Re: Edwards Aquifer, Comal County
PROJECT NAME: Westpointe Village (Discount Tire Co. Inc. TXS059), located at State Highway 46 and Loop 337, New Braunfels, Texas
PLAN TYPE: Application for Approval of a Water Pollution Abatement Plan (WPAP) 30 Texas Administration Code (TAC) Chapter 213; Edwards Aquifer Protection Program
EAPP File No.: 2873.05

WATER POLLUTION ABATEMENT PLAN MODIFICATION

**WESTPOINTE VILLAGE
(DISCOUNT TIRE CO. INC. TXS059)**

Re: Edwards Aquifer, Comal County
NAME OF PROJECT: Westpointe Village; Located near the southwest corner of Highway 46 and Loop 337, New Braunfels, Texas
PLAN TYPE: Application for Approval of a Water Pollution Abatement Plan (WPAP); 30 Texas Administration Code (TAC) Chapter 213;
Edwards Aquifer Protection Program ID No. 2873.01

SHEET
C14.0

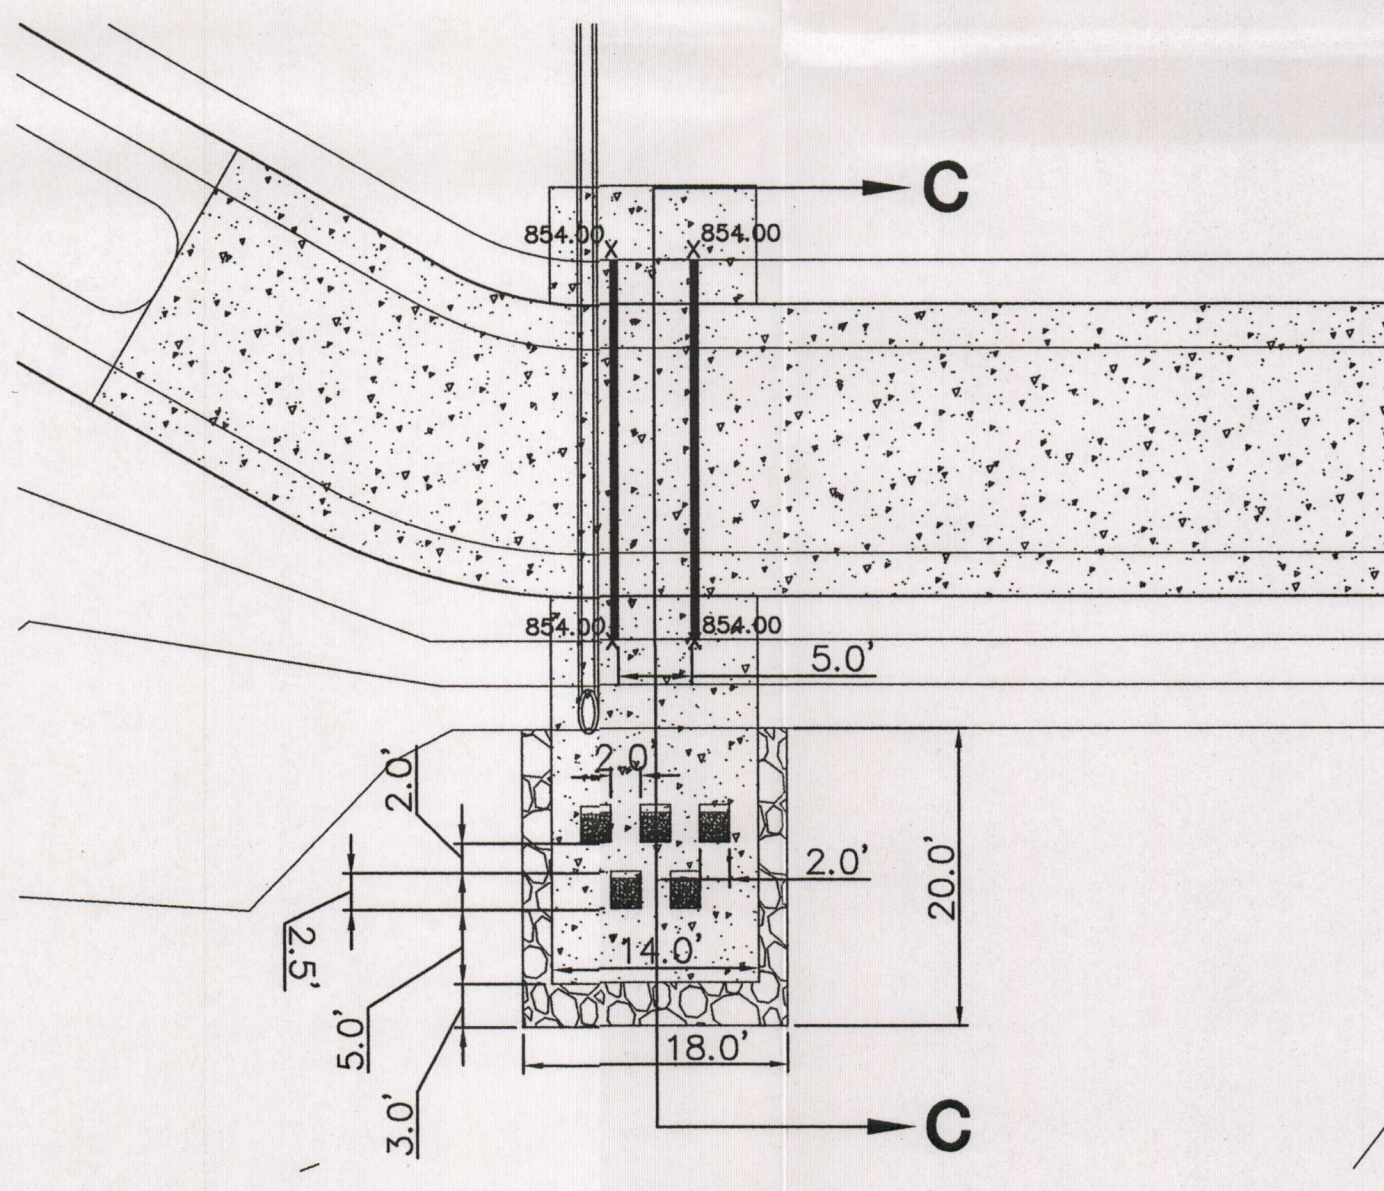
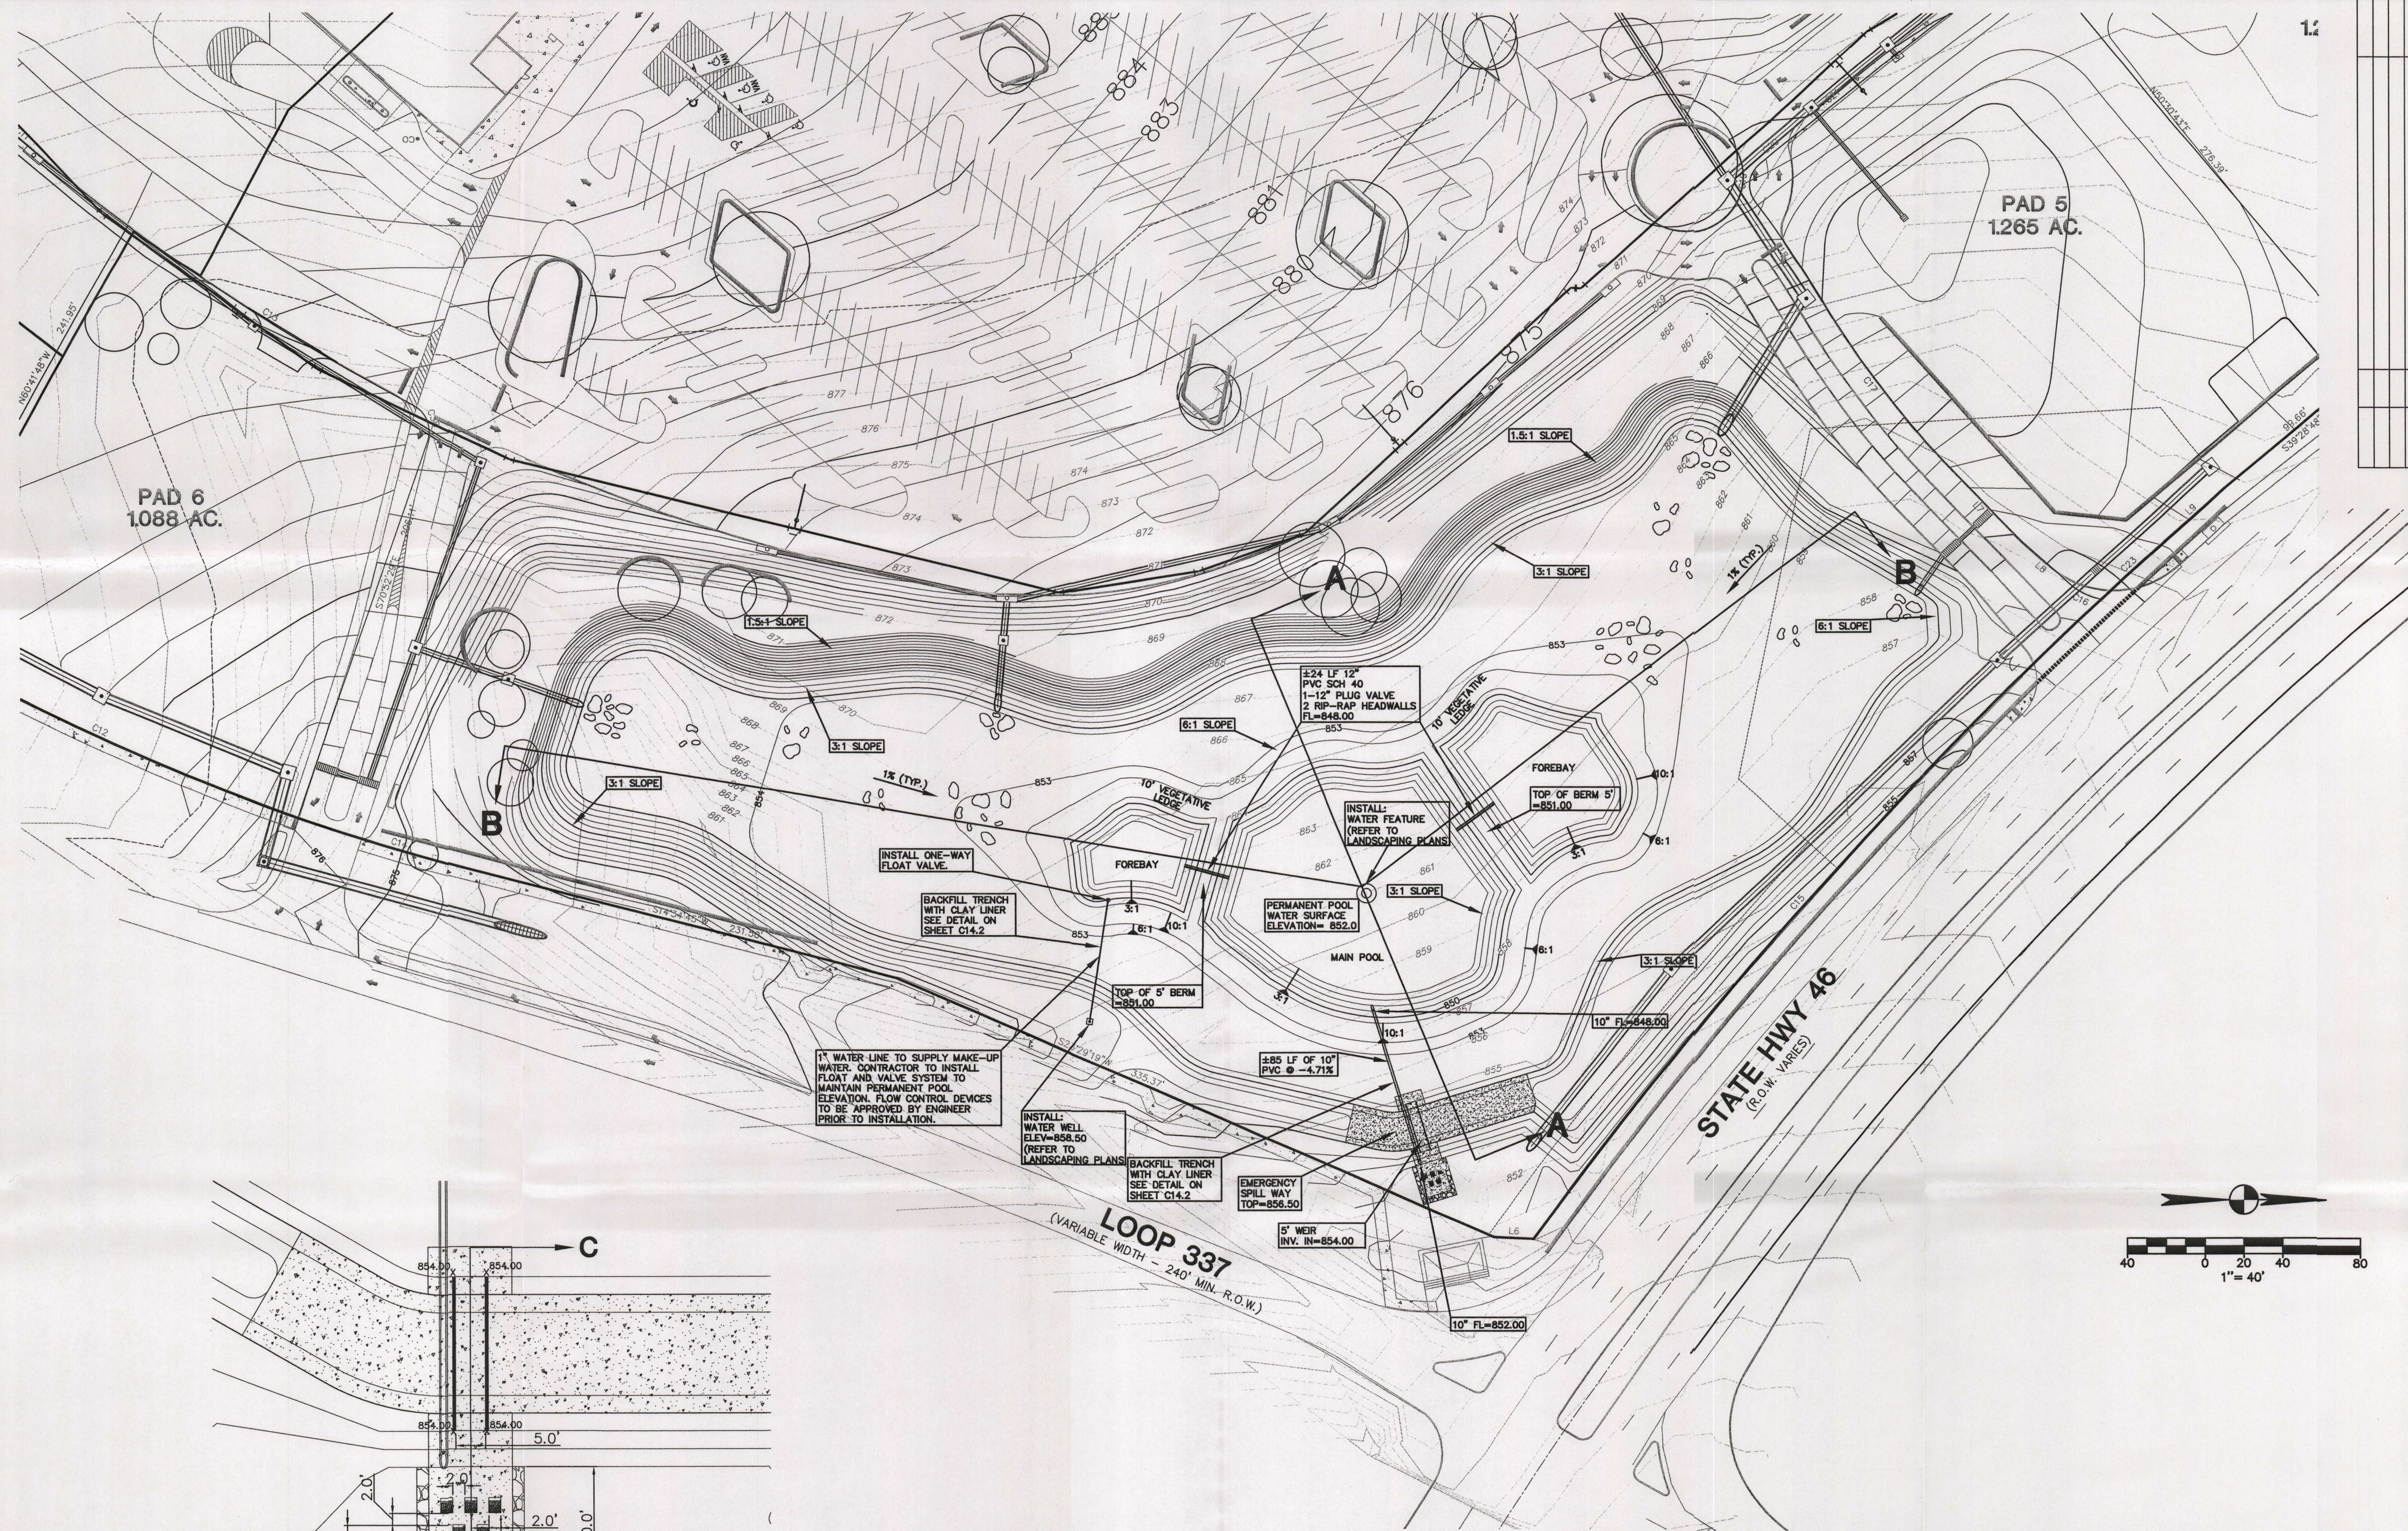
6. The Inspection, Maintenance, Repair and Retrofit Plan for the wet basin is different from those similar steps listed in the Maintenance Notes on Sheet C14.0. Please revise the necessary details for conformity between the two lists. Secondly, please have the applicant sign the updated Inspection, Maintenance, Repair and Retrofit Plan since a new BMP was proposed in the first NOD response.

4. *Comment: City of New Braunfels request Notes 4 and 5 on Sheet C14.0 be revised since they do not apply to projects within the city limits. NBU handles water lines in the city, so Note 4 should refer to NBU. Note 5 should be revised since there is not a Drainage Superintendent. Please contact James Klein, City of New Braunfels, City Engineer for further explanation.*

Response: The notes have been revised to address the above comments.

TCEQ SITE PLAN FOR DISCOUNT TIRE CO. INC.
LOT 7, BLOCK 1
WESTPOINT VILLAGE SUBDIVISION
SCALE: 1"=40'

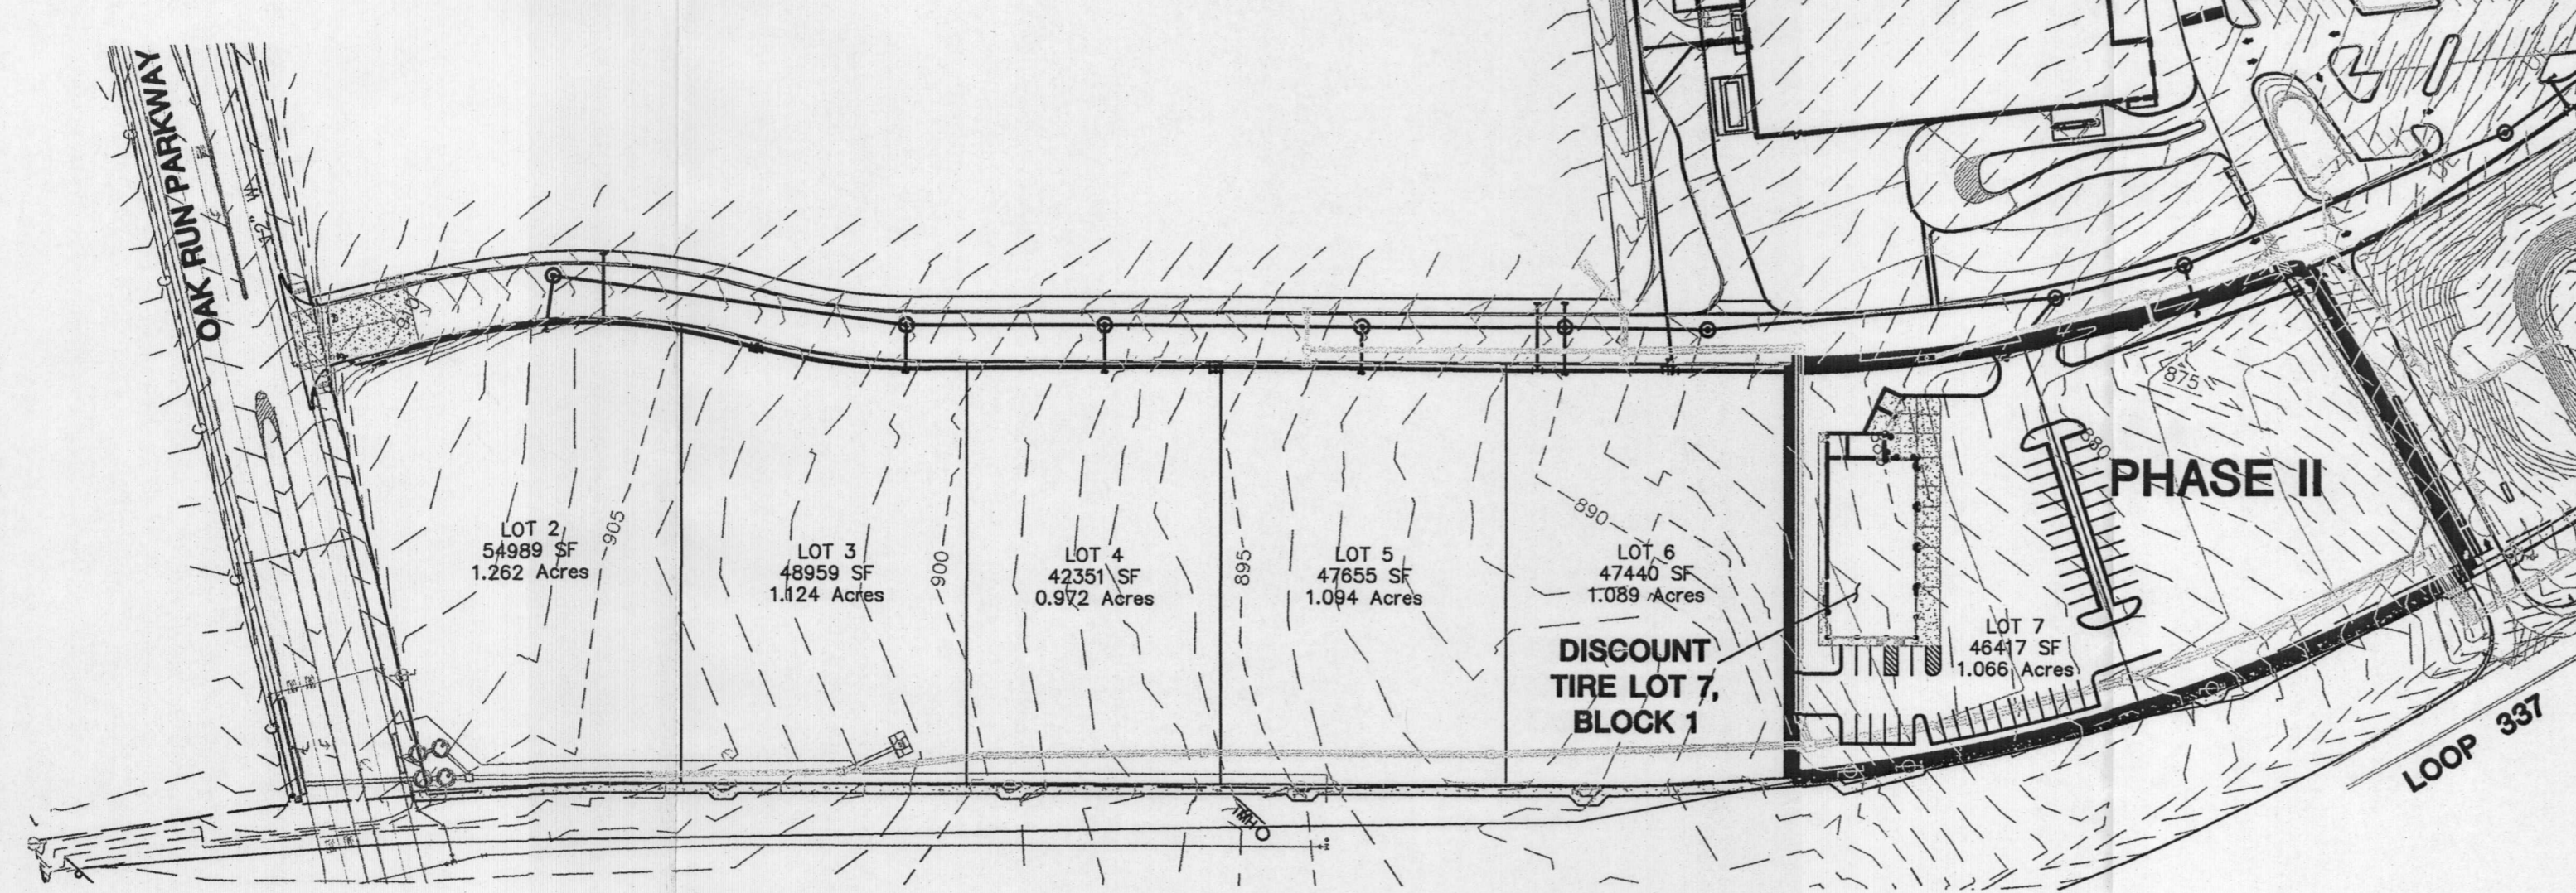
10. *Comment: Provide or revise the site plan to clearly show curbs, gutters, roadways, parking lots and building outlines. Currently, these items are too faint to clearly distinguish from the contour lines and phase boundaries.*

11. *Comment: It is not clear what type of construction activities are proposed for Phase III. Is building construction proposed in this area or just grading and utility installation activities? Update the site plan and include final contours for Phase III. Indicate the impervious cover amount, if any. If no impervious cover is proposed in this area, remove the building and parking lot outlines and state the limits on the activities that can occur.*

13. *Comment: On the Site Plan exhibit, within the 7 acre site portion, a note states, "Water well begin access denial line". Please explain this note and clarify if a water well is currently located at the site.*

Response: The above comment has been addressed.

Response: The site plan has been modified to show only the buildings that will be constructed. Phase III was removed and replaced with "By Others" since it is no longer included in this report.

Response: The 7 acre site is no longer part of this submittal.
